Redlands Passenger Rail Project
Response to
Comments on the
Draft EIS/EIR

SCH No. 20120410102

February 2015

Figure 2.1 A

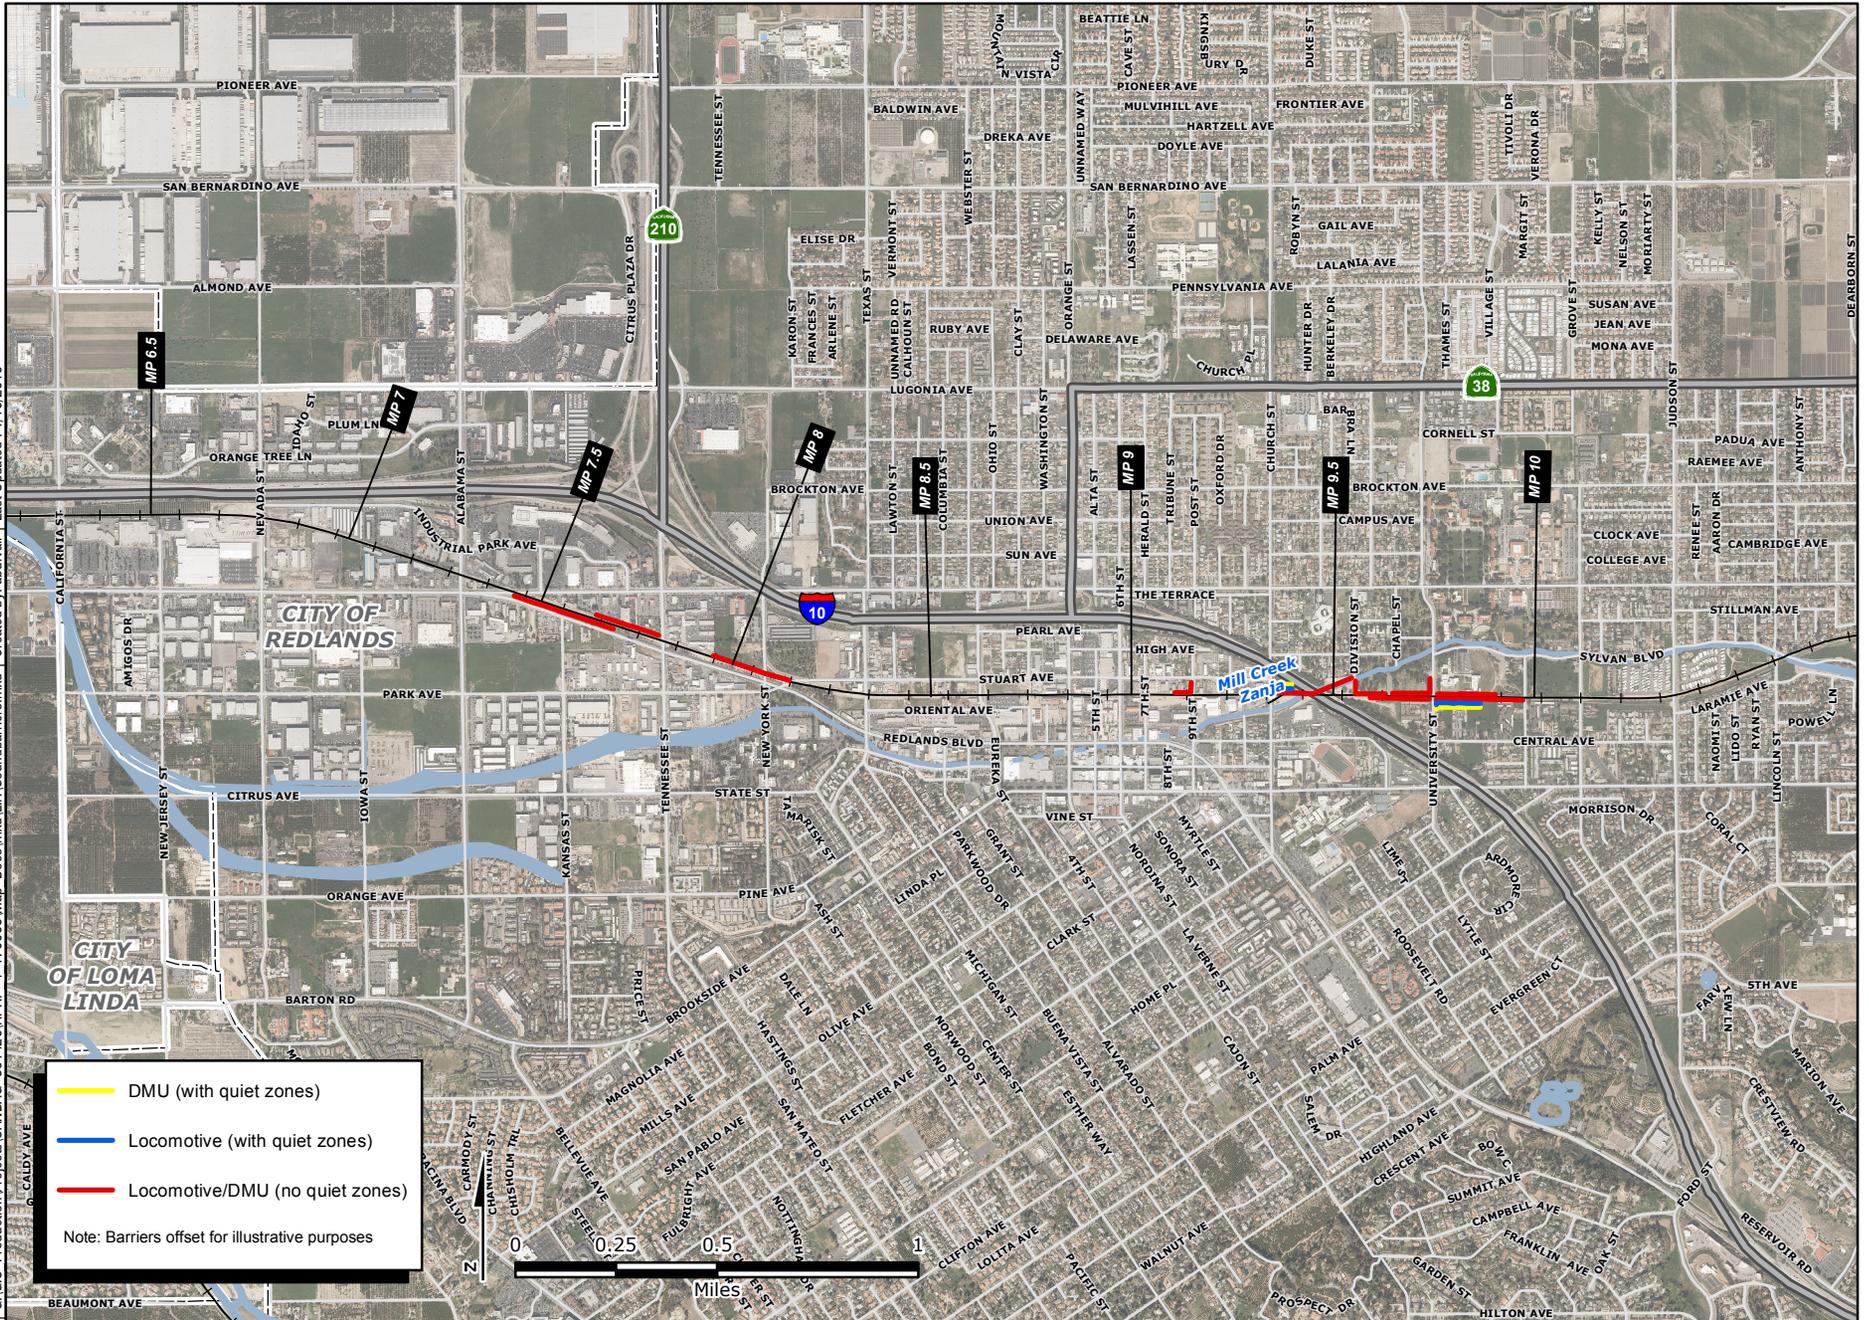
Sound barriers in the form of solid walls were considered for the four operational scenarios discussed in Master Response 1. For the locomotive vehicle option, the sound barriers shown in Figure 8-2 and summarized in Table 8-2 of Appendix H1 of the Draft EIS/EIR would be required to mitigate moderate or severe impacts in the absence of quiet zones. In total, up to 23,910 linear feet of sound barrier would be required. With the implementation of quiet zones, the length of sound barrier required to mitigate for moderate and severe noise impacts is 10,740 linear feet and as shown in Draft EIS/EIR Appendix H1, Figure 8-3 and summarized in Table 8-3. The sound barriers required under each scenario are illustrated in Figures 2-1A and 2-1B and listed below:
